WATER PERMIT NO. 2525-2

Application For Permit To Appropriate Water Within The State Of South Dakota

LONE TREE WETLAND

REPORT ON
WATER PERMIT APPLICATION No. 2525-2
Jeff Munsell & Richard Dillon
May 20, 2004

PROJECT NO. SD-0291-001	DESIGNED BY: RCS
	LONE TREE WETLAND PROJECT SITE TOPOGRAPHY	DRAWN BY: TSP
GREAT PLAINS REGIONAL OFFICE	SHEET NO. 2 OF 7	SURVEYED BY: GLJ
DATE: 2-12-2004	APPROVED BY:	CHECKED BY: BRK

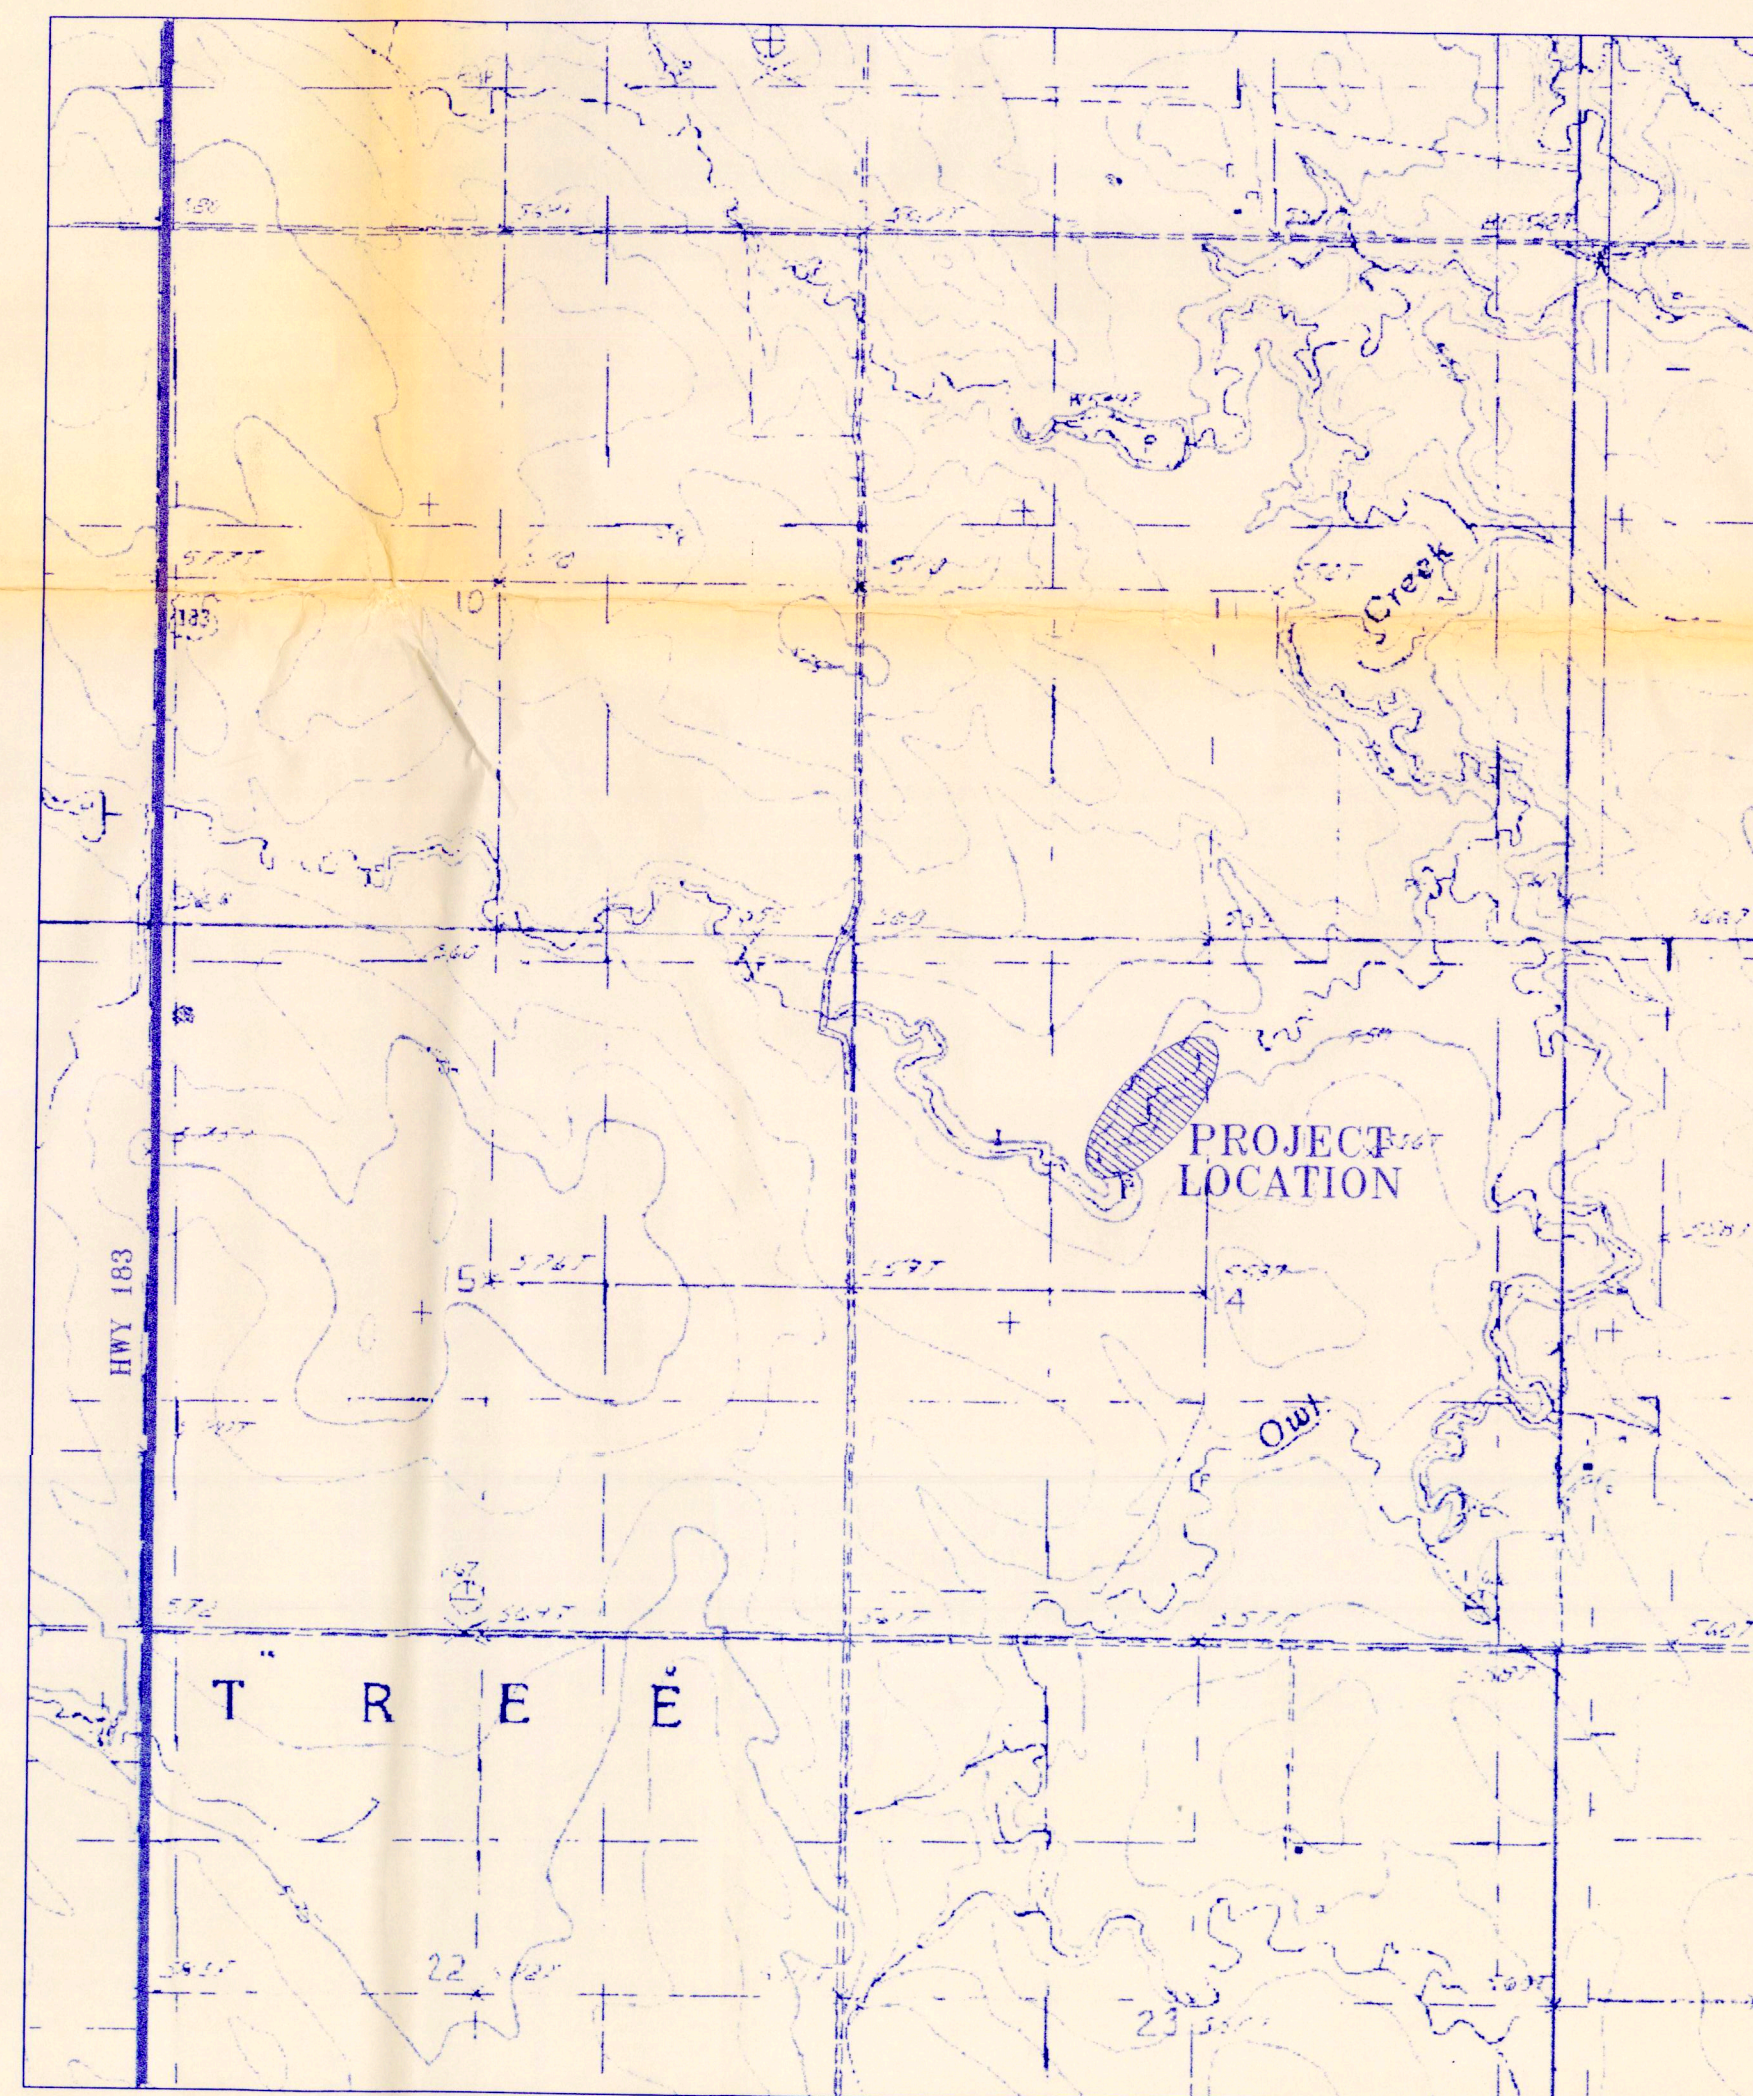
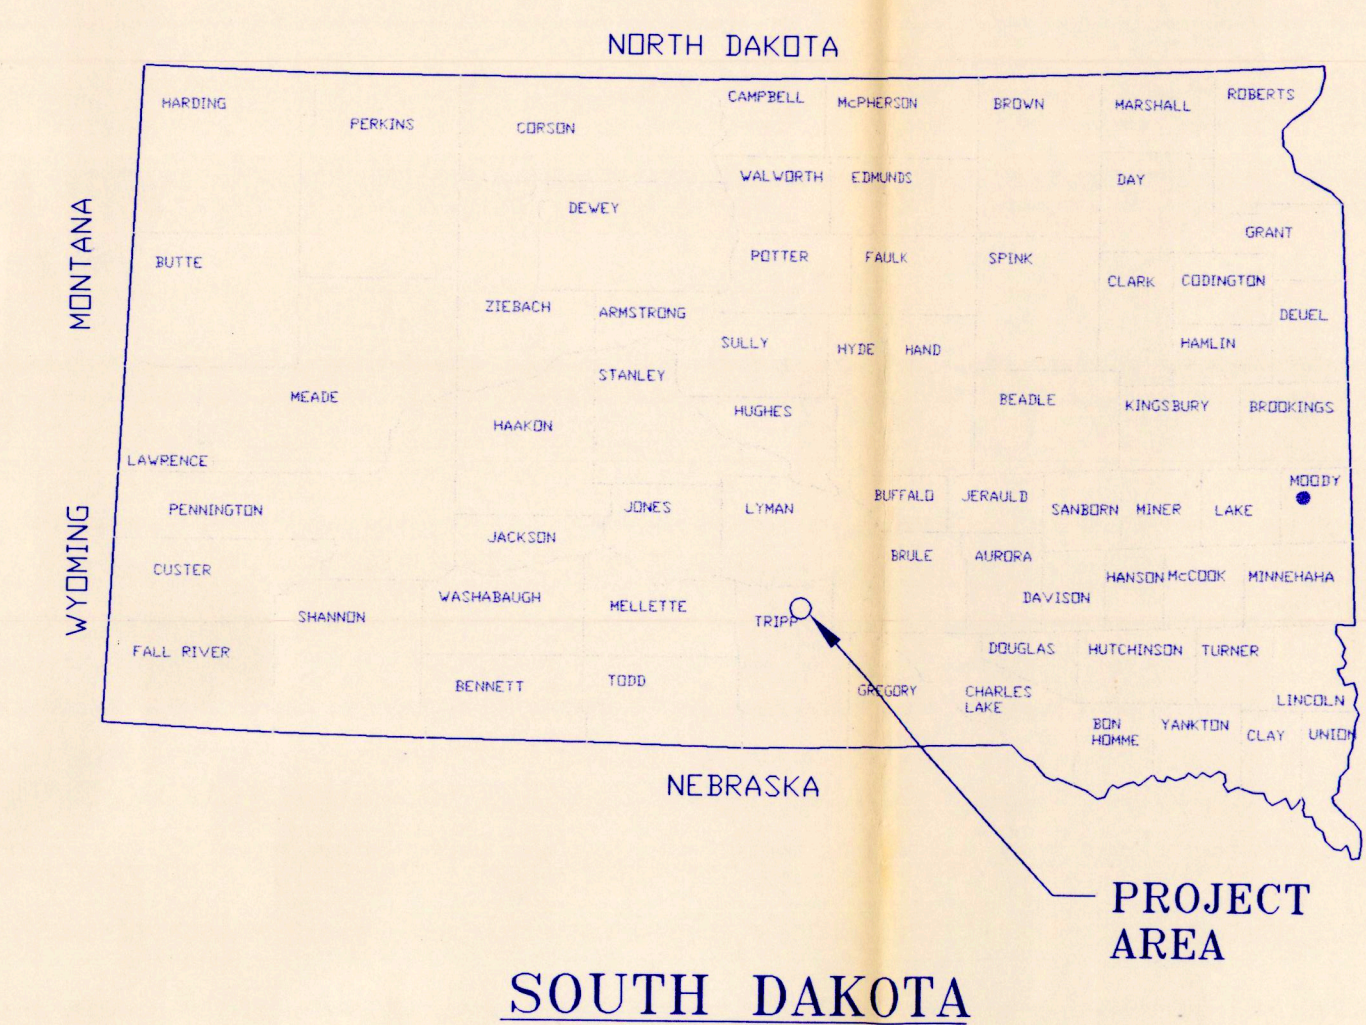
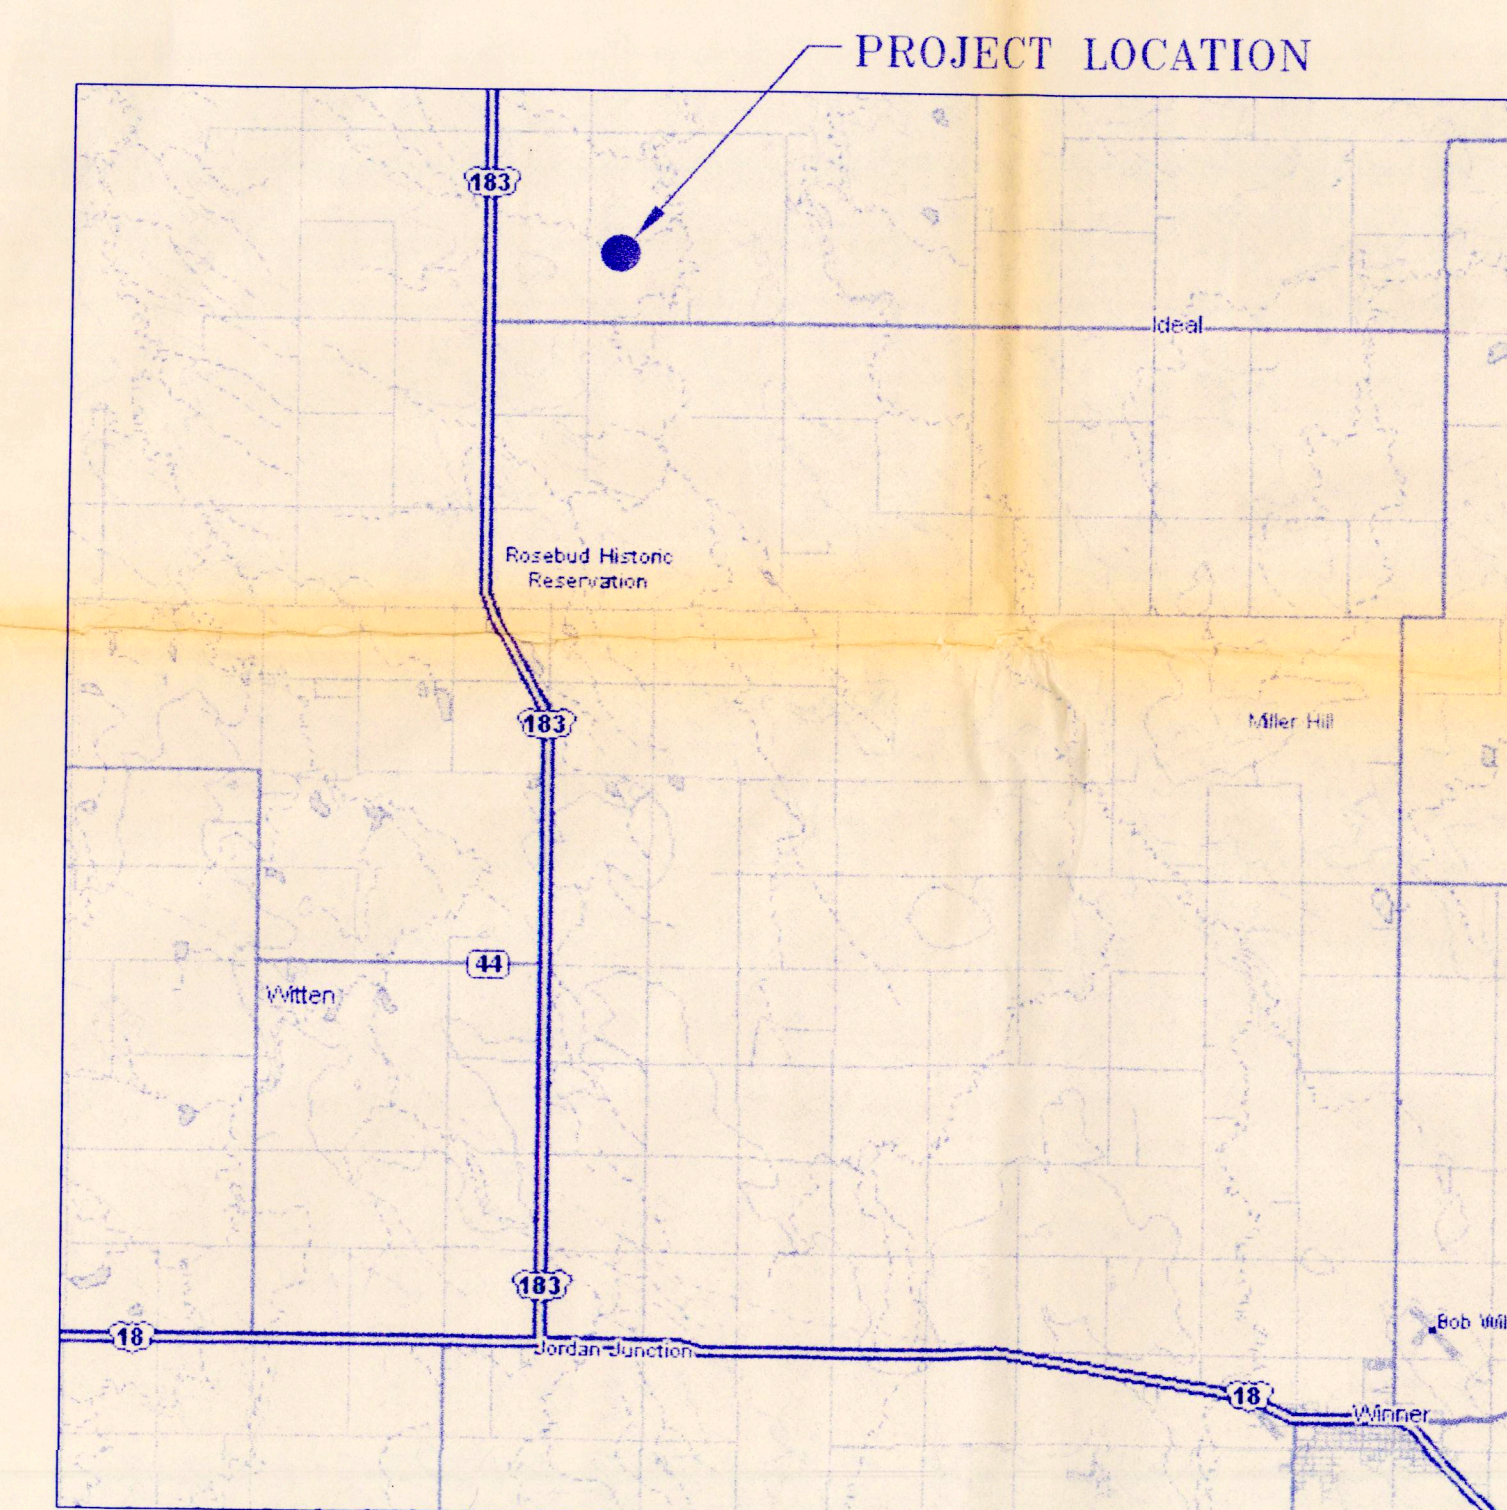
We have an approximated section corner on sheet 2. Transposing quarter lines you get the following. You are right, the dam is in the SE1/4, NW1/4 of 14. Water will be impounded in the S1/2, NW1/4, as well as the NW1/4, NW1/4, of 14. The only quadrant / of the NW1/4 not effected by the project is the NE1/4, NW1/4.

Water Rights received this application for a 56 acre foot dam. The application states the dam is located in the NE 1/4 NW 1/4 of Section 14, T101N, R77W. From looking at the maps submitted, it appears the dam structure will be located in the SE1/4 NW 1/4 of Section 14 with water impounded in the S 1/2 NW 1/4 of this section. Do you concur?
